TECHNICAL SERVICE BULLETIN

TSB-OT-0014

Subject: Ductless 17 Series, 18,000 BTU Heat Pump – Potential EEV Malfunction

Test Procedure (Continued)

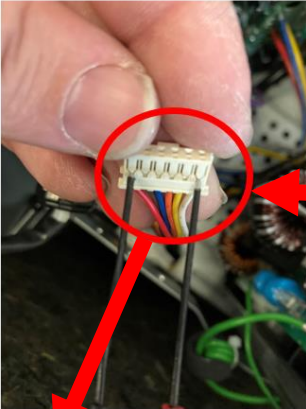
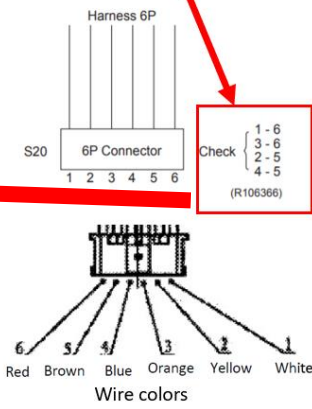
Locate the EEV plug at the S20 terminal on the outdoor unit PCB → After ensuring voltage has been discharged Unplug the S20 connector and test the resistance between below test points → Test points

Resistance values at the test points should read about 45 Ohms
 If the resistance value is open or too low (shorted) the coil has failed and will need to be replaced

If it is determined that a EEV has failed, inspect the area around the IC12 and IC13. If the IC12 or 13 has been damaged replace both the EEV and PCB.
